This SB supersedes and replaces SB-912-065UL R2/ SB-914-046UL R2 dated February 27, 2015.

SERVICE BULLETIN

Exchange of floats on ROTAX® Engine Type 912 and 914 (Series)

Exchange of floats on ROTAX® Engine Type 912 and 914 (Series)

Fig. 1

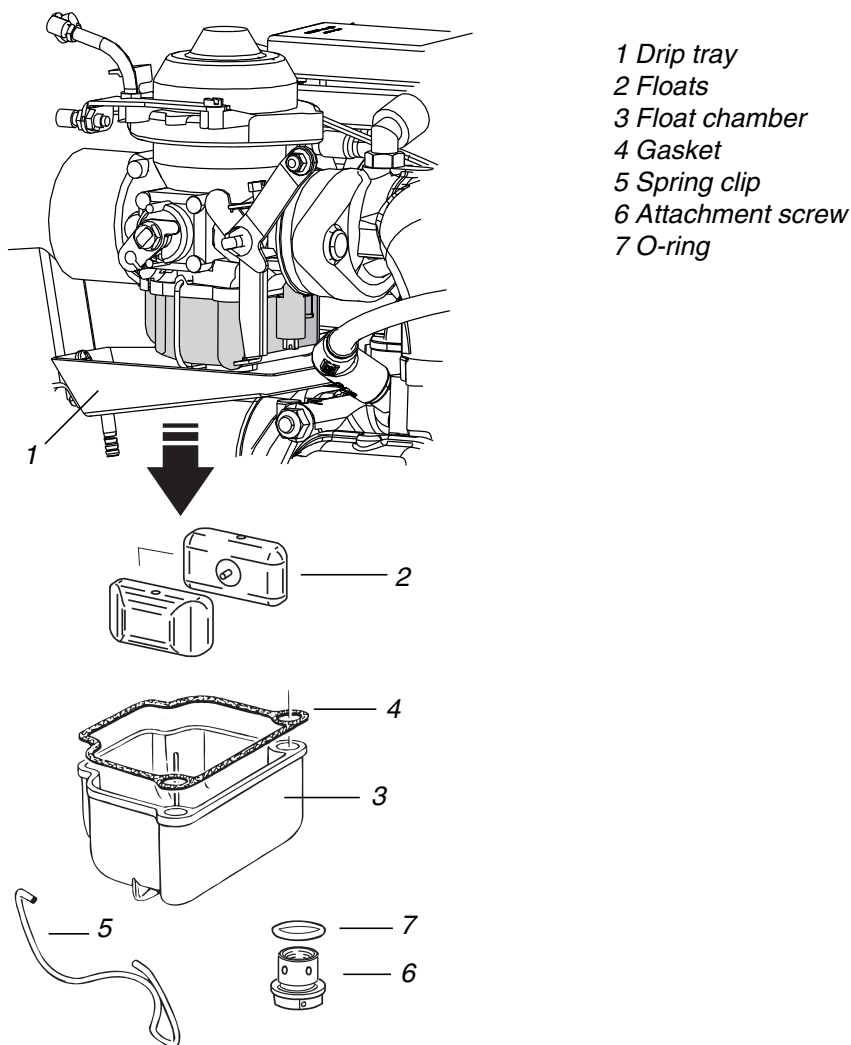
Due to a deviation in the manufacturing process some floats could absorb more fuel thus having more weight. This leads to a loss of float buoyancy and wrong regulation of the fuel in the float chamber. Possible effects may be a rough engine running, especially at low speeds and under circumstances loss of performance and/or fuel leakage in the area of the carburetor.

Step	Procedure
1	Remove drip tray (1).
2	Visual inspection of the carburetor and its mechanical actuation.
3	Remove spring clip (5) or for ROTAX 914 Series remove safety wire, loosen cap screw (6) and remove with O-ring (7).
4	Remove float chamber (3), gasket (4) and the two floats (2)

Only floats without markers have to be changed. Already marked floats (see Fig. below) must not be changed.

Step	Procedure
1	Remove the gasket (4) from the float chamber and for ROTAX 914 Series exchange the O-ring (7).
2	Install float chamber (3) with gasket (4) and both floats (2).

Step	Procedure
3	Close spring clip (5) or for ROTAX 914 Series install the attachment screw (6) including O-Ring (7) and apply safety wire. Tightening torque of attachment screw 5.5 Nm (48.7 in.lb).
4	Install drip tray (1) and/or accessories according to the instructions of the aircraft manufacturer.
